File No.: MA-DP-2020.1 (CRD)

DATE OF MEETING: September 28, 2020

SUBJECT: Development Permit Application – Anson Road Dock Facility  
Applicant: CRD, c/o Dale Puskas, P. Eng., Manager of Capital Projects  
Location: Water Lot DL 2027 – Anson Road

Figure 2 – Site Plan

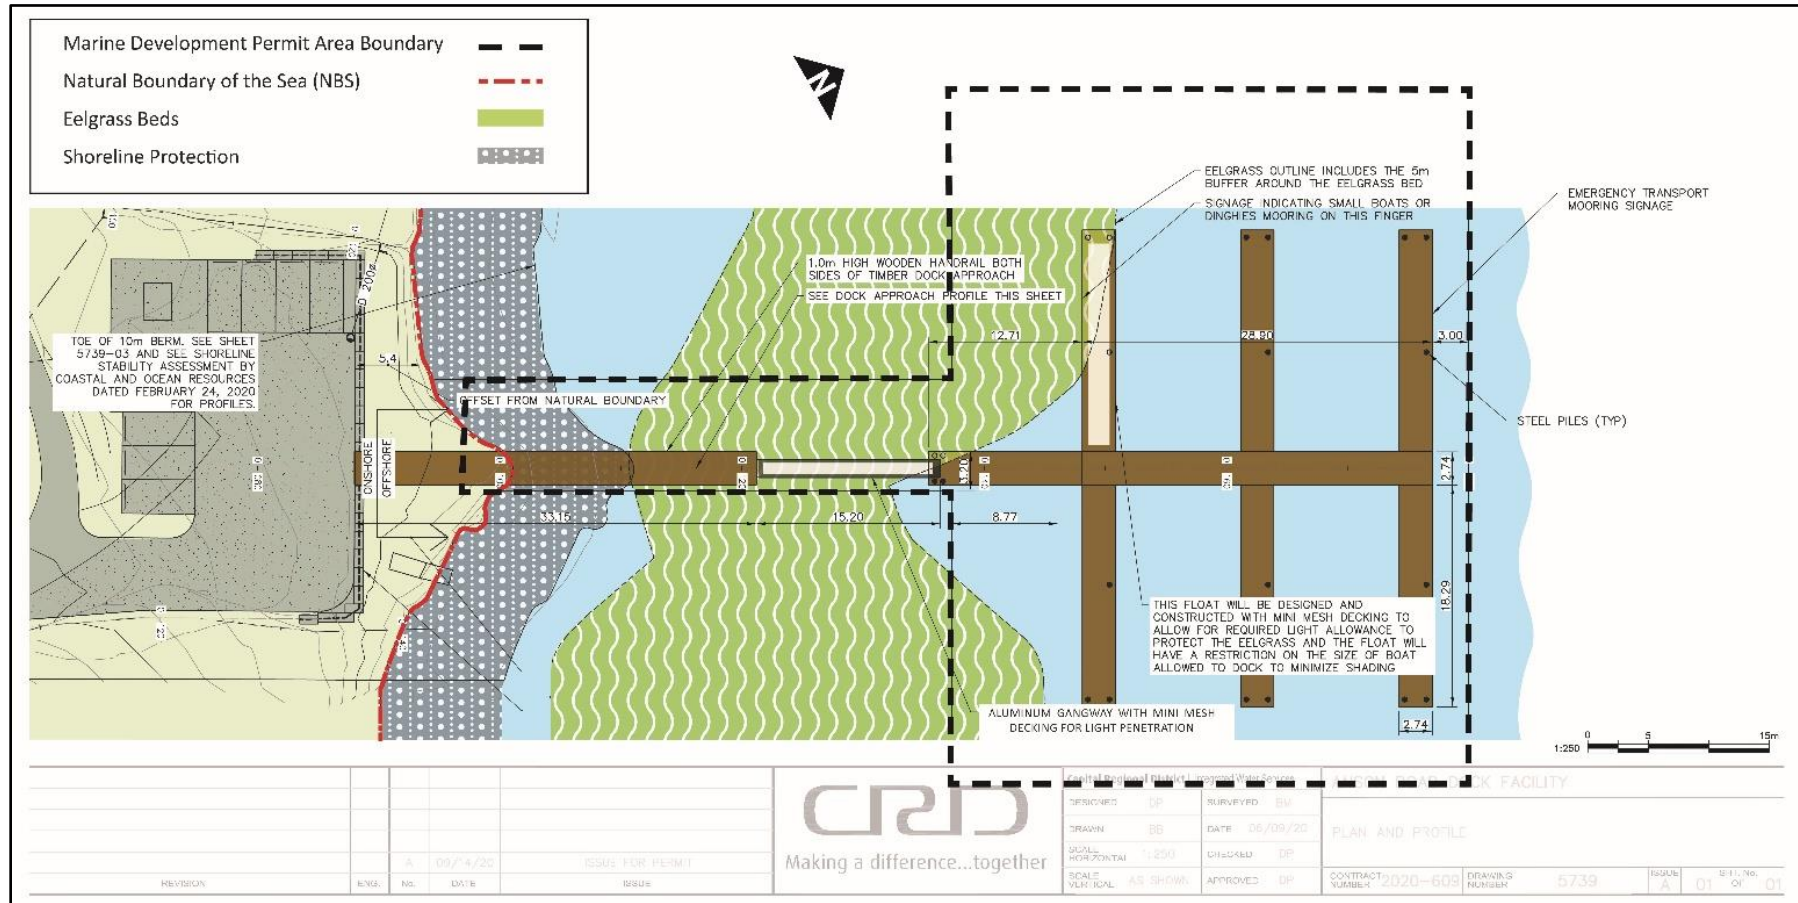
Only a very small area of land at the point where the approach ramp "lands" is designated in the DPA (see Figure 2). The remainder of the upland portion of this proposal is not part of this application as it is appropriately zoned, and there is no development permit area designated, the applicant does not require any Islands Trust approvals for that area. The EIA portion of the AEA/AIA Report has an upland component which is required to be implemented by the contractor through an Environmental Management Plan.

Staff identified that the northern extent of the lower parking lot indicates lock-block retaining wall that would be within approx. 3 metres from the Natural Boundary of the Sea (NBS). The minimum bylaw setback for structures is 7.5 metres (Subsection 3.3(2) of the LUB) The CRD was made aware of this issue and given options to conform and have confirmed that they will likely apply for a variance.

**Figure 5 – Concept Drawing ‘Green Shores’ (Recommended) Alternative**

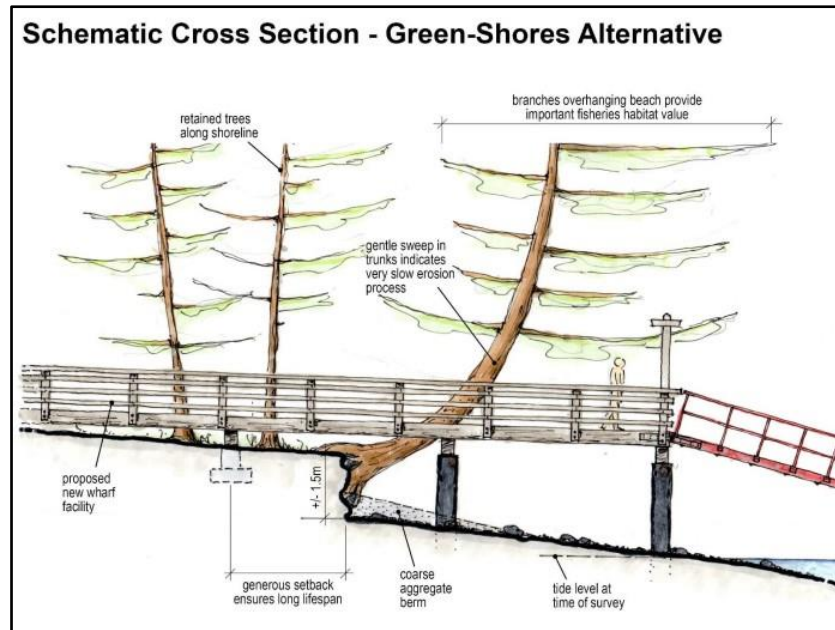
The assessment indicates the need for some form of shoreline erosion mitigation to protect the proposed infrastructure and prevent instability, particularly, for the approach (landing) feature. Several options ranging from ‘hard’ to ‘soft’ (green shore) solutions were assessed and compared (Table 2, p.16).

The assessment recommended the following approach which is illustrated on Figure 2 (above) and below in Figure 5). This includes the following elements:

1. A generous setback that minimizes the need for hard beach protection to totally arrest cliff erosion,
2. Use of beach nourishment to create a protective berm at the toe of the cliff; material should be sufficiently coarse so as (a) to minimize transport from the site and (b) to provide infiltration for waves action.
3. Working around existing trees as much as possible to preserve riparian overhang and to leave root systems to help bind cliff material.

This alternative is specified by the CRD and will consist of 19mm (3/4 inch – approx. material) have a thickness of 1 metre (at the natural boundary of the sea - NBS) that tapers to <0.1 metres, 10 metres seaward from the NBS (see Figure 2 and 3).

I have reviewed the Shoreline Stability Assessment report (Coastal and Ocean Resources, 24 February, 2020 (noting footers indicate 30 May, 2020)) and talked with John Harper today about the preferred, protective beach berm (beach nourishment) as a soft shore solution for the shoreline erosion concerns at Anson Road.

I agree with this being the preferred option out of all the options identified in the report based on:

- The application of a soft shore solution is generally always preferred from an environmental perspective as it is more natural and my understanding is these solutions don't "transfer" the erosion issue further along shore like hard shore solutions can;

- The recommended fill material size (19 mm or 0.75") is within the range of the native substrate size within the tidal elevation range where fill material is recommended (up to 10 m out from natural boundary);

- The toe of the fill material is recommended to 10 m out from the natural boundary, which is approximately +2.0 m (above chart datum). This provides a sufficient buffer to ensure there is no direct overlap with the subtidal eelgrass that was observed in 2019 during the dive surveys as shallow as ~-0.75 m (below chart datum);

- The combination of the fill material being coarse and well sorted (i.e., not mixed with fines) will help keep the fill material in place and prevent migration downslope and sedimentation effects on eelgrass;
